NABI: MATA - Underseat Heater Gasket Replacement

Property and TopBus Number:
WMATA 325000 & 325500 – 8001 thru 8105.

Issue: Under seat heater gasket

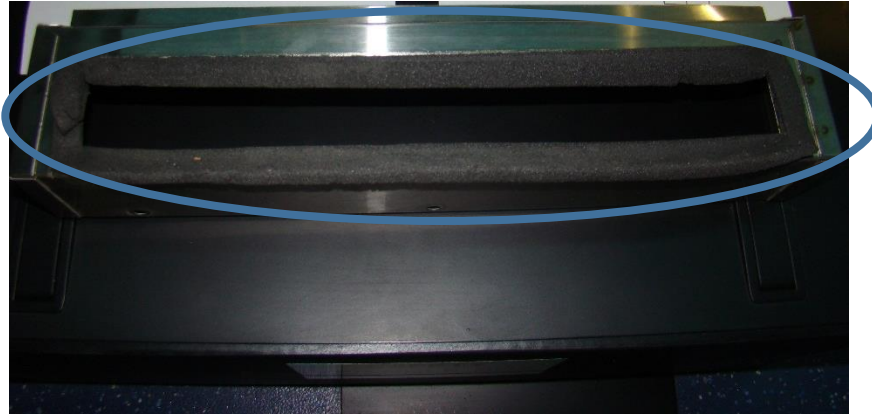
3. Remove the five screws that fasten the duct bracket of the under seat heater (see below).

4. Remove existing foam seal using a scraper and discard foam seal (see below).

5. Install McMaster Carr PN: 1120A223 seal to the duct bracket as shown below (see below).
